Editor comment: Theory of the generalized chloride mass balance method for recharge estimation in groundwater basins characterised by point and diffusive recharge

Method discussion in the review process

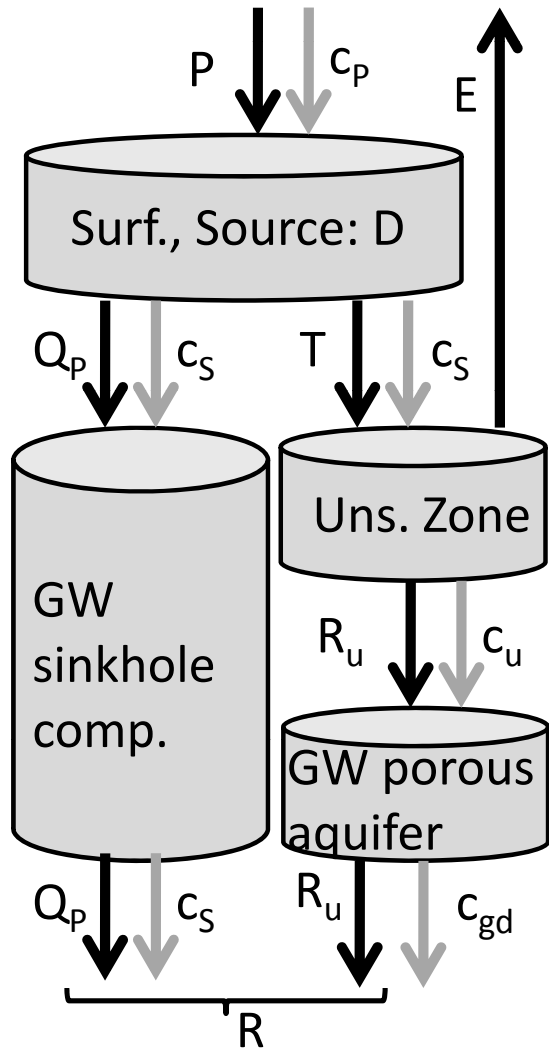
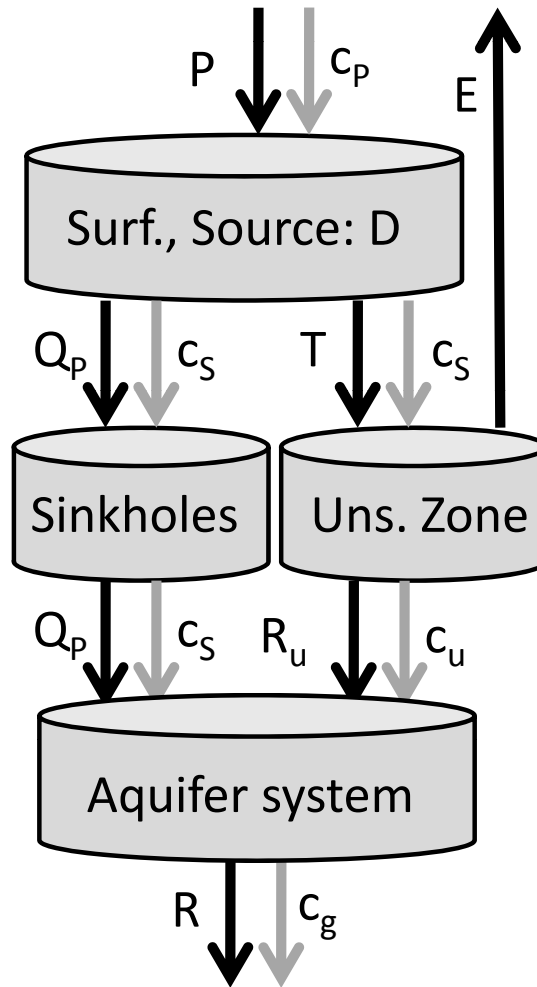
In the first approach, inserting the right hand side of eq. (7) into (6) and inserting into (5), solving for R_u and inserting this into (3) yields eq. (13c) in the manuscript. The equations (13a), (13b) and (13d) in the manuscript are special cases of this equation. This illustrates that the concept of the balance in the paper is a groundwater system of two compartments, sinkhole system and porous aquifer, which do not exchange water or chloride.

That the mass balance in the manuscript does not cover the other two cases can be illustrated by solving these systems for the total recharge R . In the second approach (meaning that complete mixing is assumed in the groundwater system), inserting eq. (6) into (8) and inserting into (5) yields

This is what the authors refer to as the conventional method. If the groundwater system is considered as one zero-dimensional system (thus fully mixed), it does not make any difference if there is sinkhole flow or not. If the third approach would be taken (meaning that some water from the sinkhole system discharges into the porous aquifer and is there mixed) yields (inserting eq. 5 solved for $F c_s$ into eq.(6) and inserting this into the right side of eq. (9), solving for $R_{u',out}$ and inserting into eq. (4))

The third approach is somewhat pointless, because it requires that a good measure of the discharge from the sinkhole system into the aquifer is available.

The recharge with the three approaches could have been written down intuitively, but due to the long debates about mixing in the review process, I wanted to clarify this point with the balances. To summarize: In the approach of the manuscript, no mixing between sinkhole water and porous groundwater is included.
